**Tinex Group Ltd, Te Puna Station Road Existing Activities – Transportation Assessment Additional Information**

Tinex Group Ltd seek consent for the existing yard-based industrial activities at 245 Te Puna Station Road, Te Puna. A Transportation Assessment Report has previously been prepared, the report dated 28 November 2022. Council has requested further information. This report provides the further information on transportation issues.

**Figure 1: Warrant for Right Turn Lane**

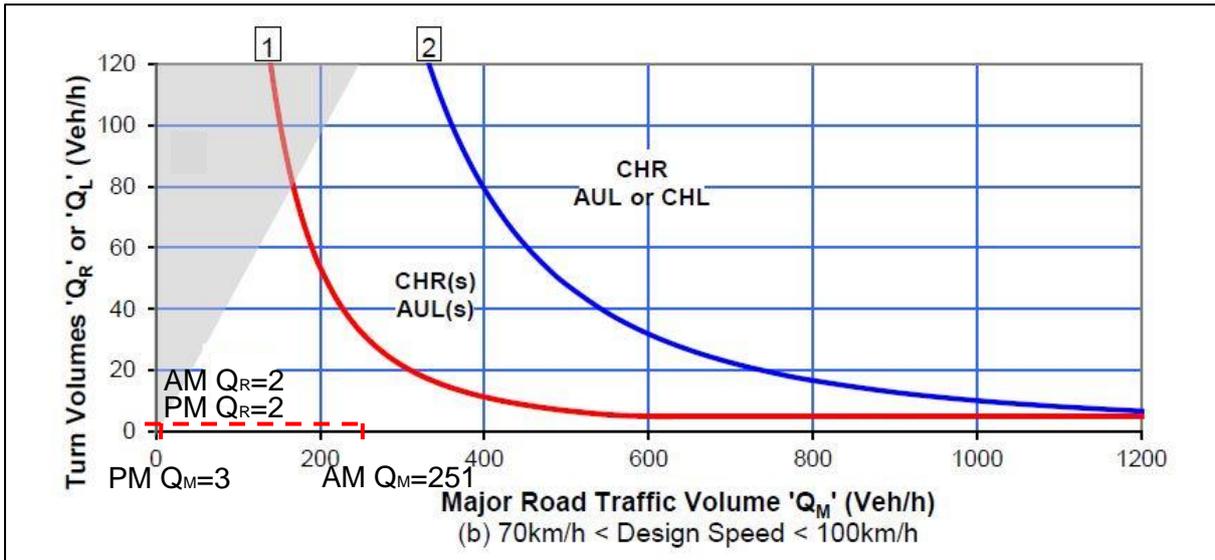
An assessment of the warrant for the provision of a right turn bay at the vehicle entrance during both the morning and evening peaks was given in the previous transportation assessment report. With the closure of Te Puna Station Road to east of the site, the through traffic volumes on Te Puna Station Road have decreased and vehicles that were previously expected to turn left into the site will now turn right into the site. An updated assessment is given in the following figure.

Figure 1 shows that the existing peak hour right turn volumes are significantly less than the volume required for a right turn lane to be warranted.

While the provision of seal widening at an access is typically required at lower volumes than for the provision of a right turn bay, the above assessment shows that the expected turning volumes are significantly less than those required for the provision of a right turn bay.

It is noted that, if the traffic volumes on Clarke Road reduce once the current road works on SH2 are completed, then the morning peak hour volume on Te Puna Station Road (shown as AM  $Q_M$  on the above figure) is also expected to reduce. This will further lessen any need for seal widening on Te Puna Station Road.

**Figure 2: Death and Serious Injury Crashes by Movement Type**

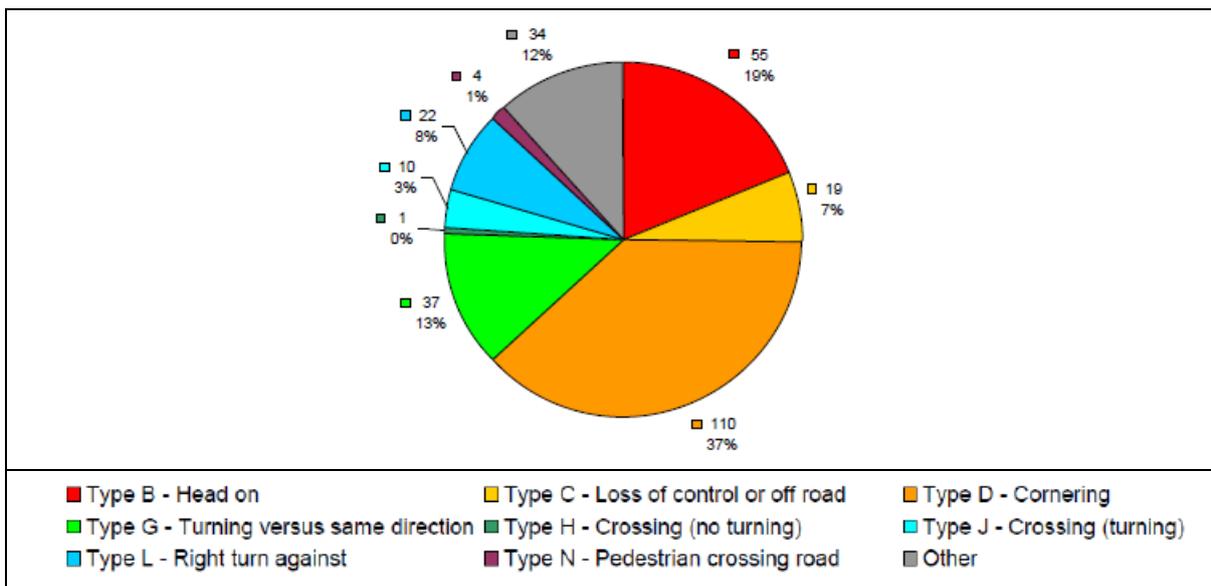
Further guidance is available in the NZTA *“High Risk Intersection Guide”*. For rural uncontrolled intersections, which are the closest intersection type to a private vehicle entrance, the proportion of intersection crashes and casualties by crash movement type is shown in the following figure.

Figure 2 shows that the majority of crashes resulting in a death or serious injury (DSI) are associated with movement types D (cornering), and B (head-on). The provision of road widening opposite the access will typically address type G (turning, same direction) crashes, which account for a low (13%) proportion of rural uncontrolled intersection DSI crashes.

In summary, given the decrease in traffic on Te Puna Station Road following the slip, the low peak hour turning movements and the low proportion of type G crash types at a rural entrance, it is assessed that the provision of road widening opposite the vehicle entrance is not required.

INDUSTRIAL DEVELOPMENT  
LOT 2 DP22158  
PROPOSED ACCESS LAYOUT (SITE 1)

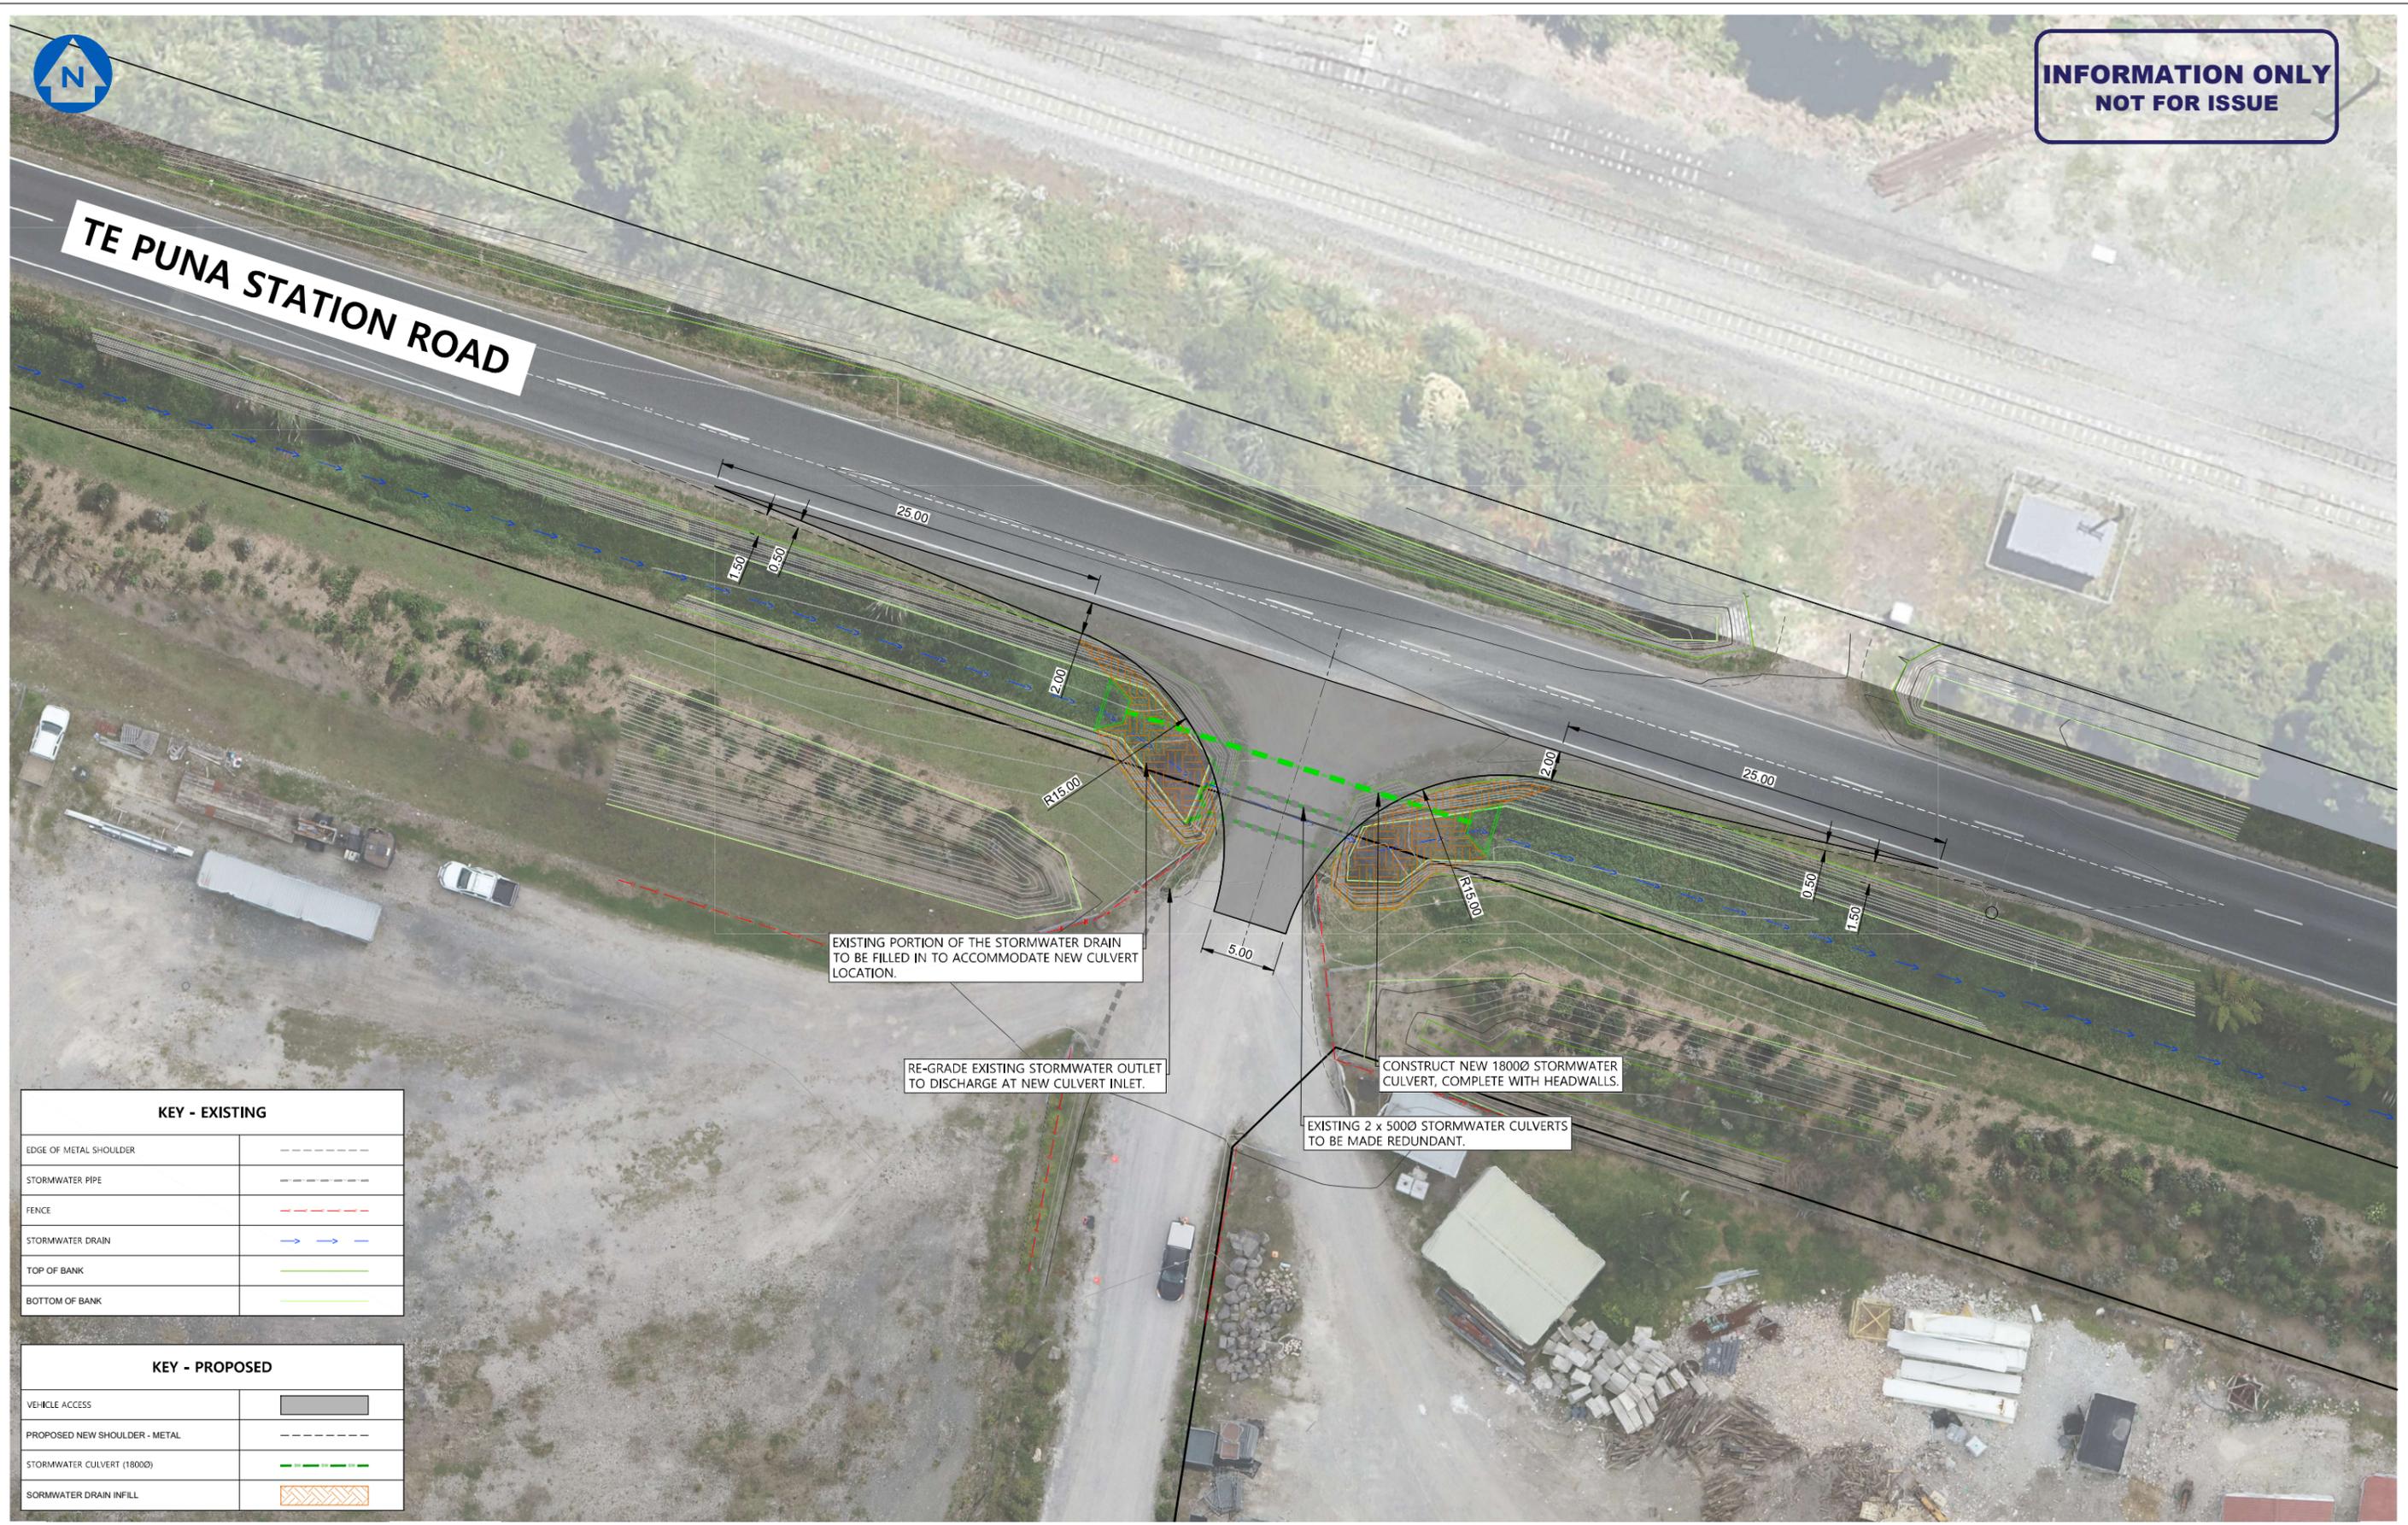
Council has queried whether any physical works are required for the proposed upgrade of the vehicle entrance. It is confirmed that physical works are required, as shown on the attached Stratum Consultants drawing 423022 CIV D001, sheet 02.
